# St. Lucie Unit 2

## NRC Update SL2-13 November 2001 Steam Generator Inspection Plans

STEAM GENERATOR TUBE INSPECTION DISCUSSION POINTS  
 PREPARED BY THE OFFICE OF NUCLEAR REACTOR REGULATION  
 FLORIDA POWER AND LIGHT COMPANY  
 ST. LUCIE PLANT, UNIT 2  
 DOCKET NO. 50-389

STEAM GENERATOR TUBE INSPECTION DISCUSSION POINTS  
PREPARED BY THE OFFICE OF NUCLEAR REACTOR REGULATION  
FLORIDA POWER AND LIGHT COMPANY  
ST. LUCIE PLANT, UNIT 2  
DOCKET NO. 50-389

13

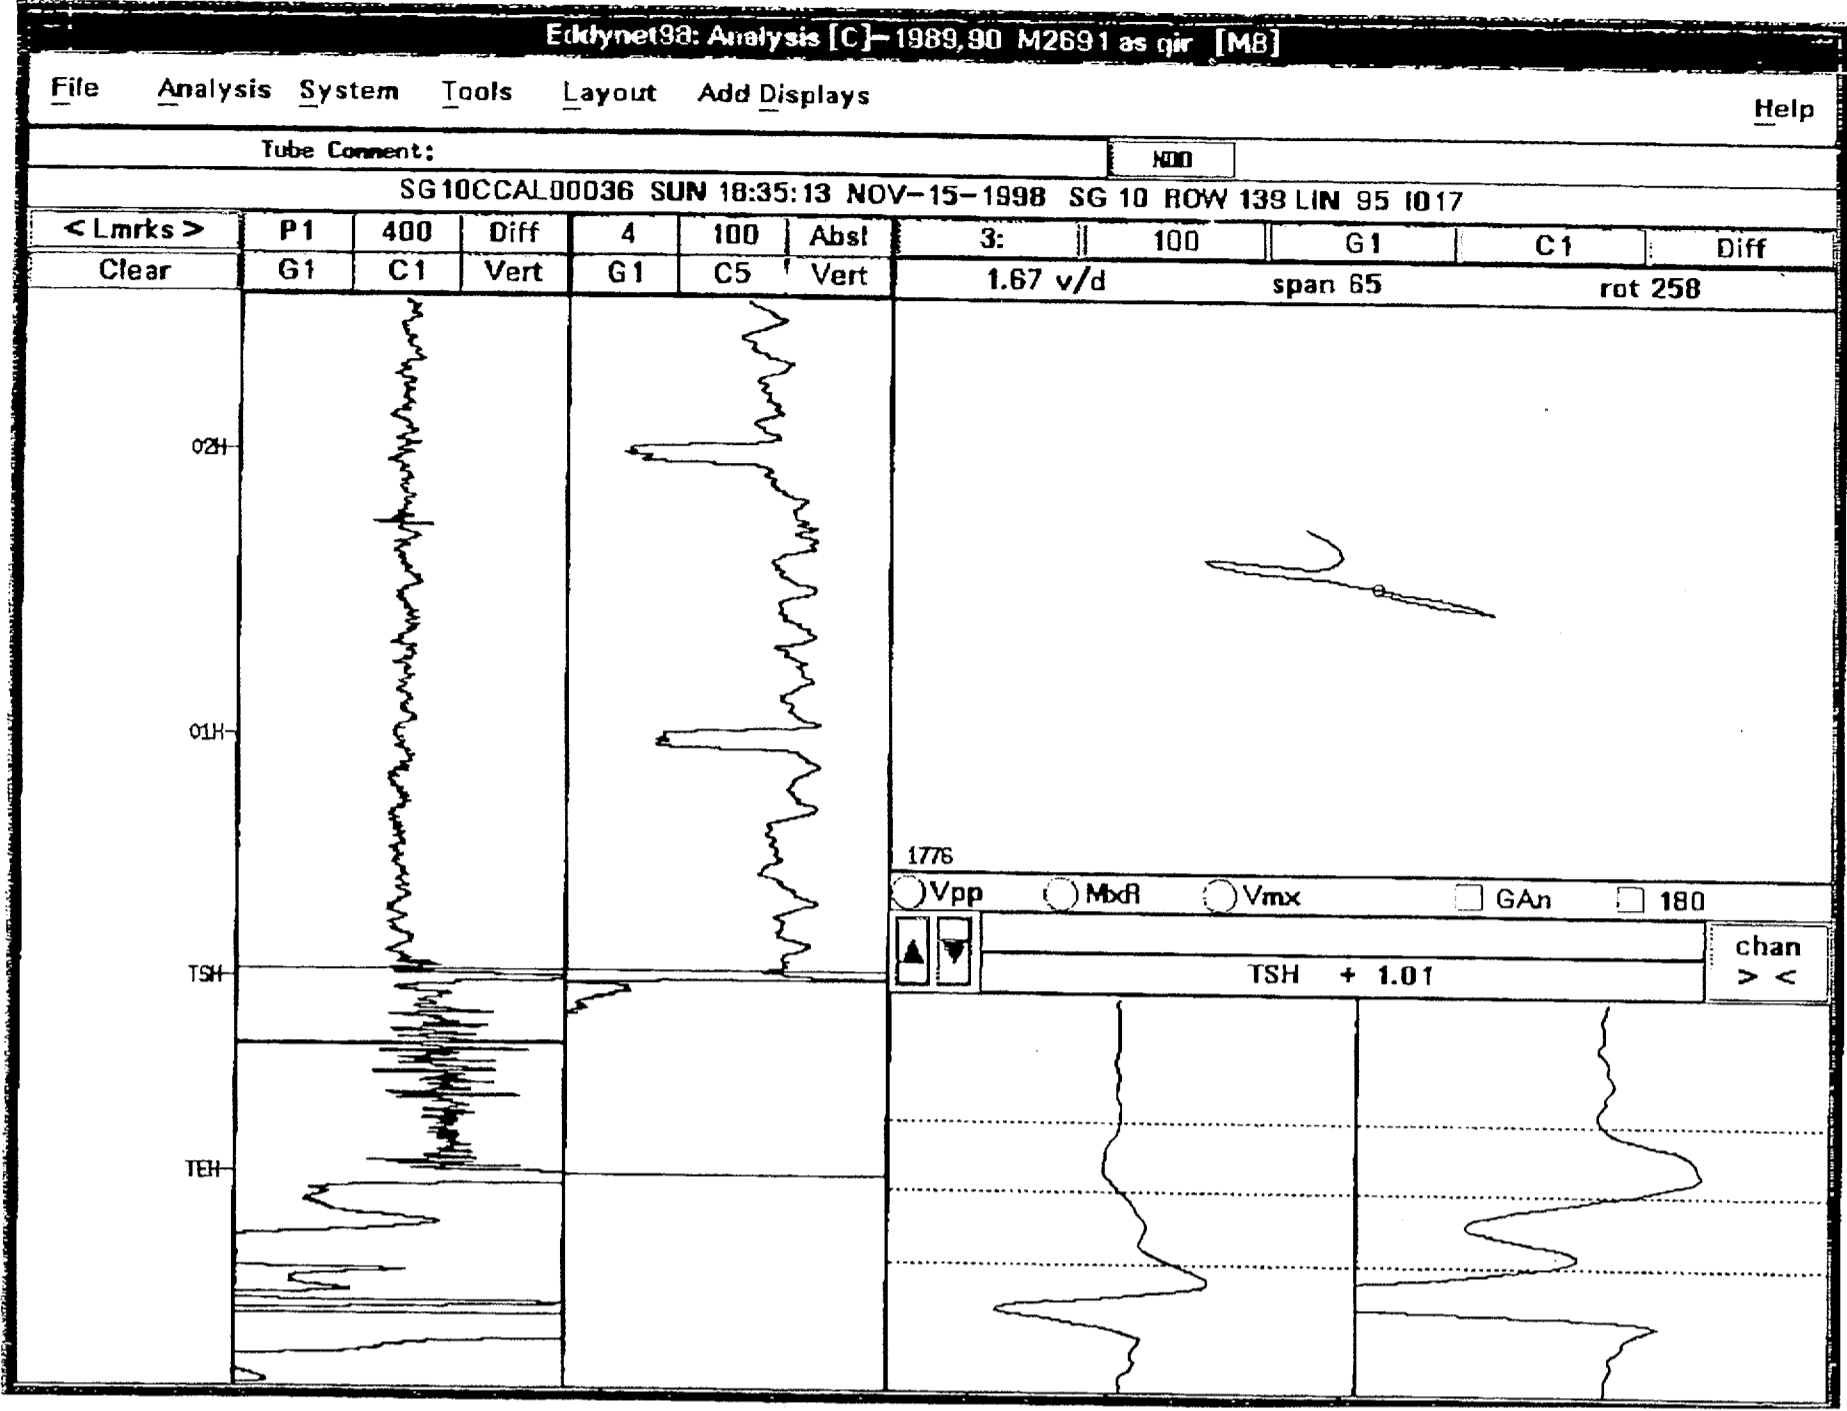
**Issue 1:** Provide eddy current graphics and discuss the evolution of the worst indications detected in dents (See Attachment 1 – 13 Pages).

# HOTLEG TUBESHEET RISK MODEL

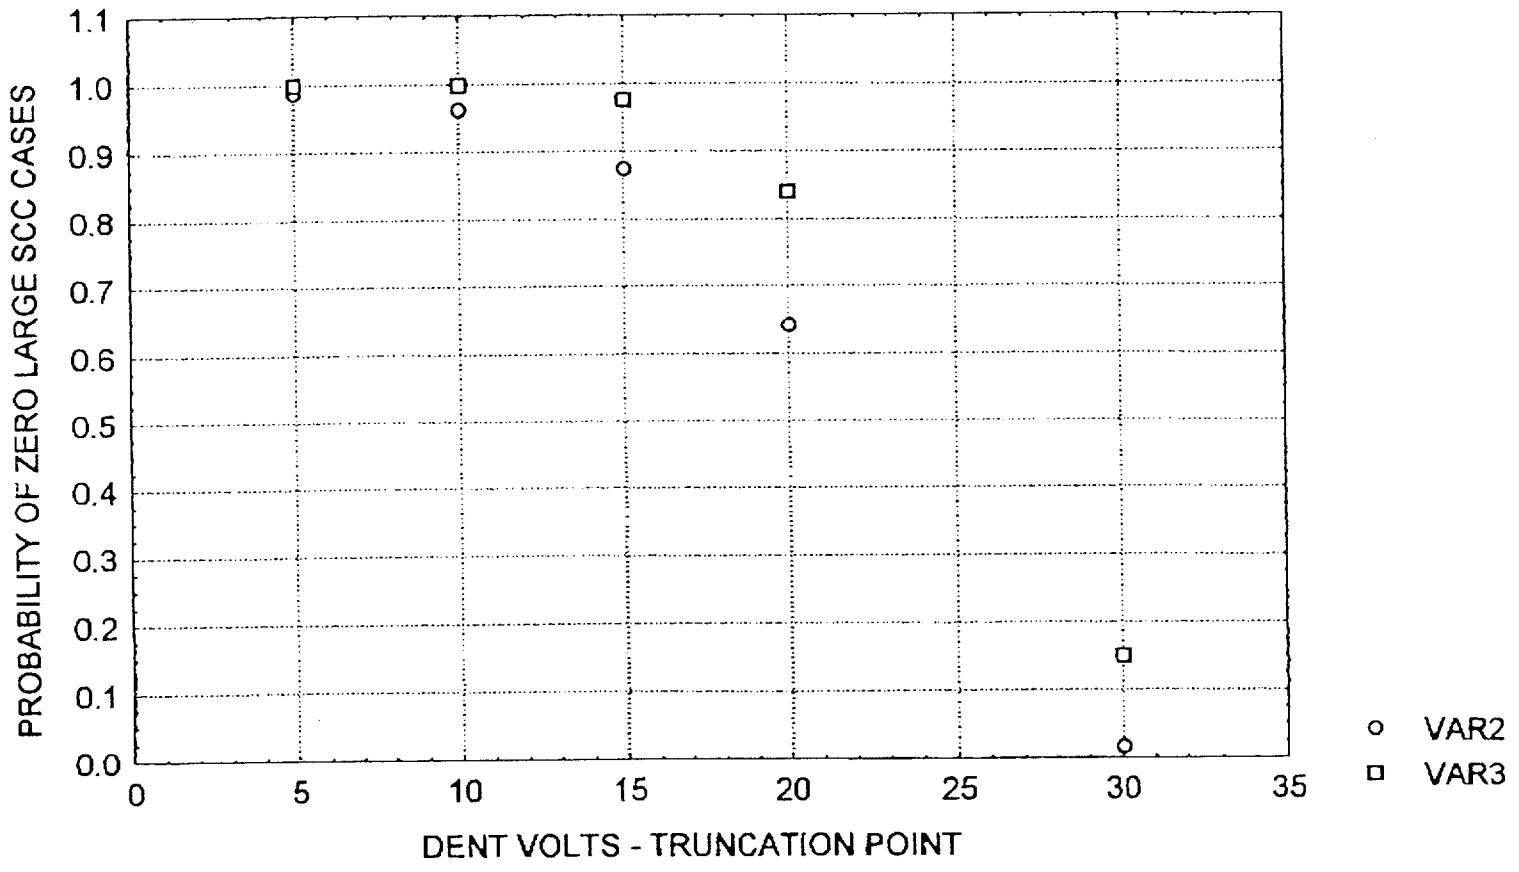
**Issue 4:** Discuss why plugging dents 10 volts and greater for dents between the hot leg tubesheet and the first support is adequate. Discuss what the scope of inspections has been (See Attachment 2).

- BASED ON SG-A DATA [4 SCC INDICATIONS]
- HIGHEST RISK
- LOGISTIC REGRESSION MODEL
  - CONDITIONAL PROBABILITY OF SCC GIVEN DENT VOLTAGE
  - APPLIED TO INDIVIDUAL TUBES
  - COMBINED OVER VOLTAGE SPECTRUM
- RISK VS REPAIR LIMIT FOR TUBESHEET AREA

TUBESHEET RISK VS REPAIR LIMIT  
[HOT LEG TUBESHEET]
